Volume II – Appendices

Draft EIS Distribution and Review

Draft Environmental Impact Statement and Draft Finding of No Practicable Alternative for Implementation of Area Development Plan at Davison Army Airfield, Fort Belvoir, Virginia

Fig. 1. Accotink Sediment from Route 1 Widening

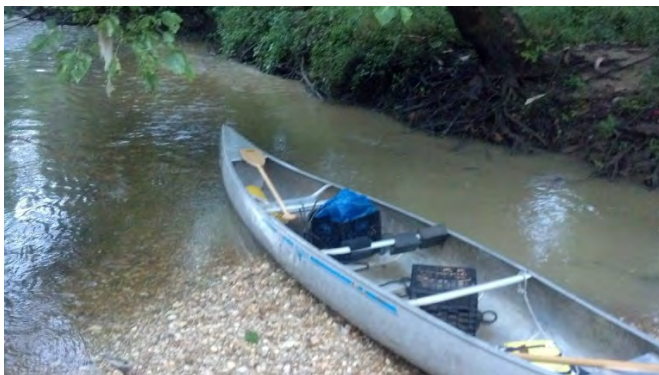
Closer to DAAF, we noted in 2017 the excessive sedimentary runoff into Accotink Creek from the Route 1 widening just downstream from DAAF, as recorded in Figure 1, contrary to VDOT's obligations to limit water resource impact. We look forward to the Army's success in preventing such runoff during the DAAF modernization. Similarly, we have noted the extreme erosion of the Accotink banks Near Fort Belvoir's Anderson Park (to be partially paved over by Project 6), as recorded in Figure 2), and we hope the DAAF modernization will actually reduce such erosion with aggressive application of BMPs for storm water management.
